IPRenewal NPEmails

From: Gray, Dara F [DGray@entergy.com]
Sent: Monday, August 08, 2011 6:44 AM
To: Stuyvenberg, Andrew
Cc: Bessette, Paul M.; Sutton, Kathryn M.; Dacimo, Fred R.; YOUNG, GARRY G
Subject: FW: Follow up to email from Friday
Attachments: Hudson Modeling Report_22Mar10_wApps.pdf

From: Mark Mattson [mailto:mmattson@normandeau.com]
Sent: Friday, August 05, 2011 7:53 PM
To: Julie Crocker
Cc: Craig Swanson; Gray, Dara F
Subject: RE: Follow up to email from Friday

The ASA report "Hydrothermal Modeling of the Cooling Water Discharge from the Indian Point Energy Center to the Hudson River", 22 March 2010 presents a series of figures and text addressing plume extent, again for the extreme condition defined in the report. I have attached a PDF copy of this report in case you do not have one readily available and want to refer to it while reviewing this response (hopefully your email server will accept a 7 meg attachment).

Figure 7-9 Plan view of the model predicted surface water temperatures showing the downstream extent of the plume at slack before flood during the Scenario time period.

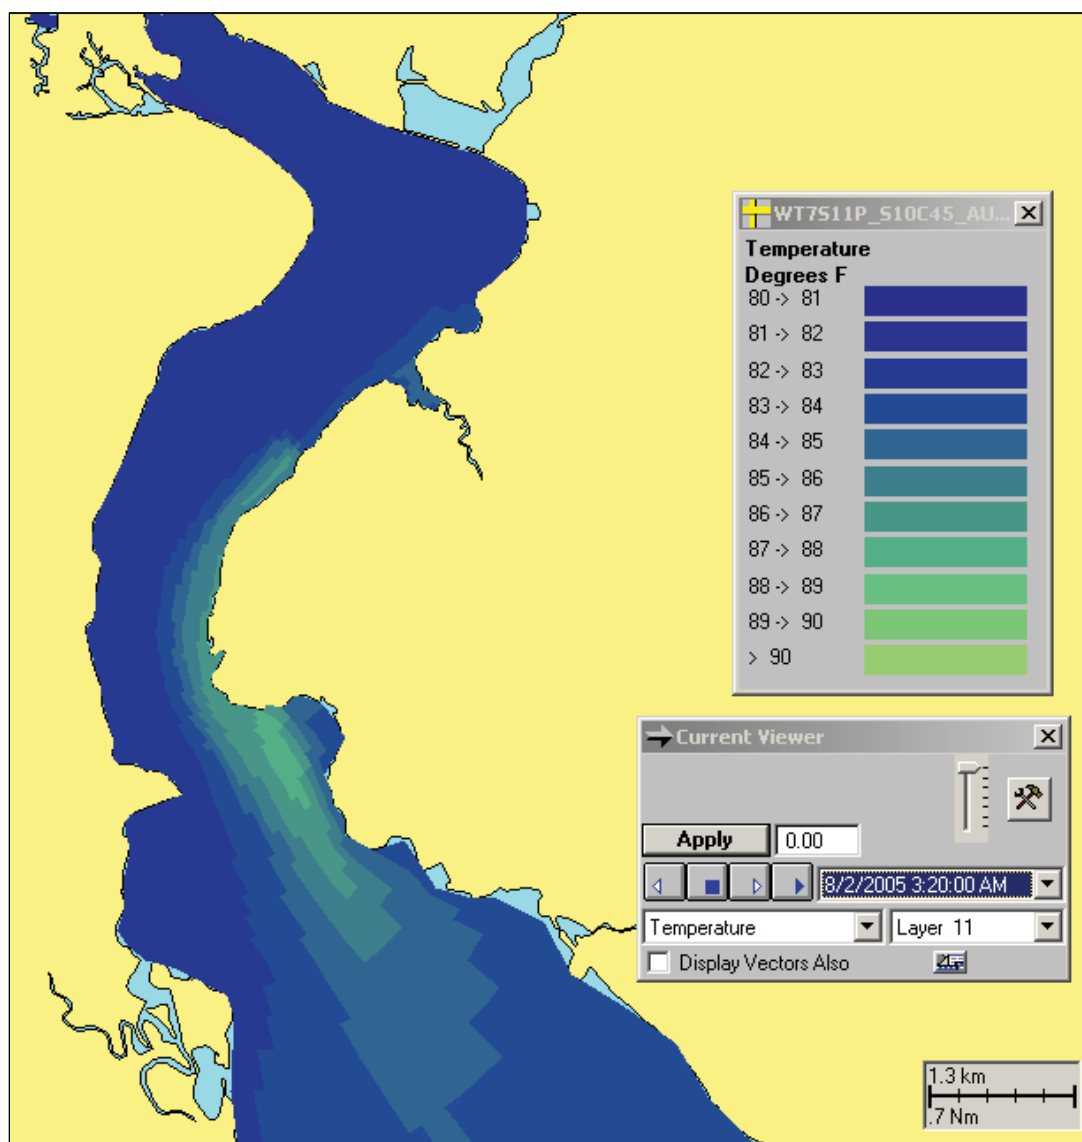
Your inquiries about the lateral extent of the plume are addressed in Figure 7-9 on page 63 and Figure 7-10 on page 64. These two figures show the maximum surface plume extent for two stages within the dynamic tidal cycle, slack before flood and slack before ebb, respectively. Ambient conditions are represented by the dark blue color in the plan view color contour maps of the temperature in the river. Discussion of these figures is given on page 62 of the report. Because this is a surface plume, its scope will be larger than any other dimension measured, e.g., bottom or mid-water column, which enters a factor of conservatism in the figure with respect to your question.

Figure 7-14 Thermal plume evaluation at the four transects for the 4°F above ambient isotherms for the Scenario time period. Top: cross-sectional area coverage. Bottom: cross-river distance along the surface.

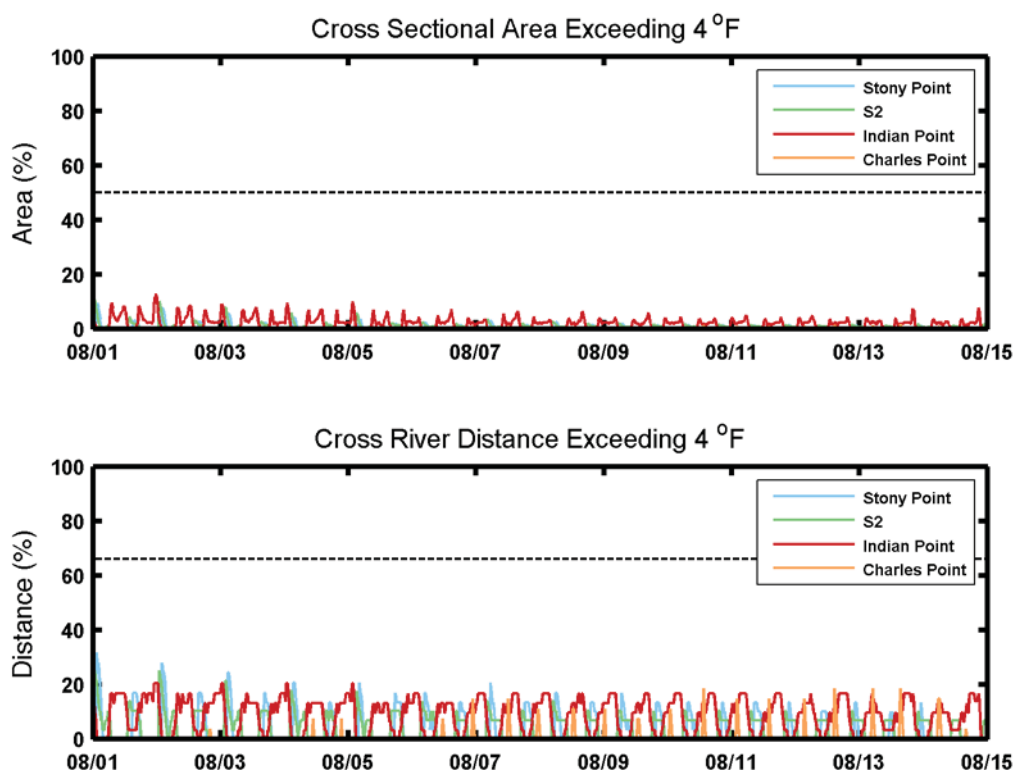
Detail about the surface plume extent can be derived from the percent area coverage of the 4°F and 1.5°F criteria related delta temperatures above ambient background shown in Figure 7-14 and Figure 7-17, respectively. As summarized on page 73 of the report:

"the model results for the simulation time period showed that the 4°F temperature rise covered less than 15% of the River vertical cross sectional area at the transects at all times during the simulation period, and generally

covered less than 3% of the cross sectional area. The model results also showed that the 4°F temperature rise surface extent was less than 35% across the River at all times, and generally less than 20%. Thus the model results show that the plant is in compliance with the NYSDEC thermal WQS.

Figure 7-15 Plan view of the model predicted surface water delta temperature above model predicted ambient for the Scenario time period with the largest cross-sectional area coverage greater than 4°F.

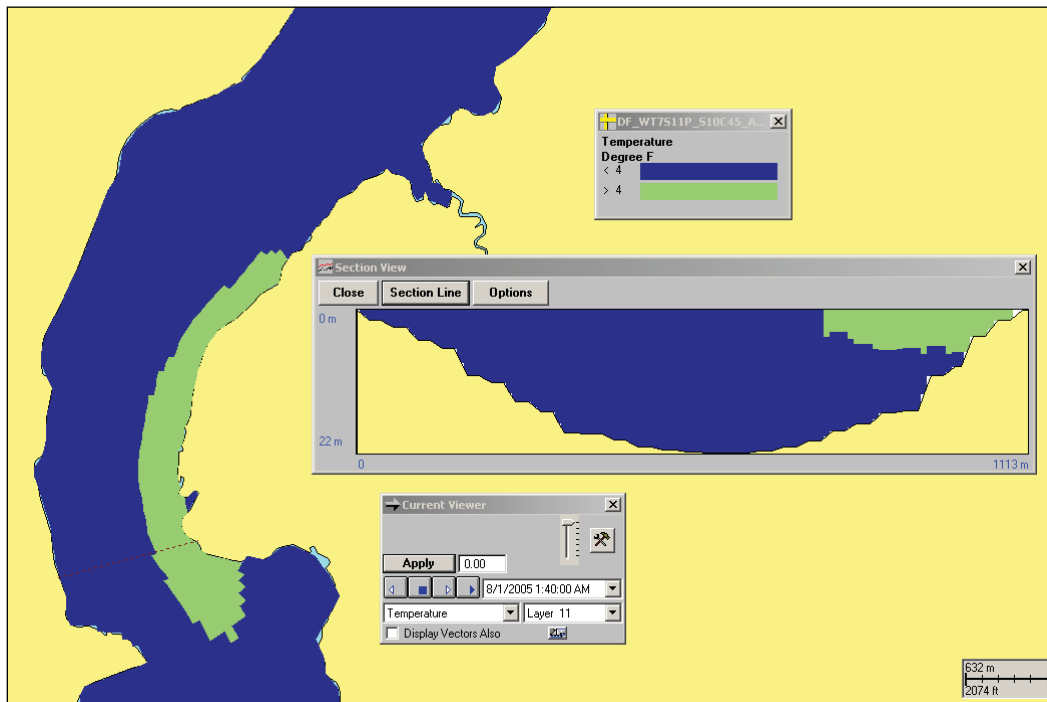
Your inquiries about the vertical extent of the plume are addressed in Figure 7-15. That figure shows both the horizontal extent of the 4°F delta temperature above ambient and a vertical extent of the plume for a section downstream of IP, just north of Stony Point, under the studied extreme conditions.
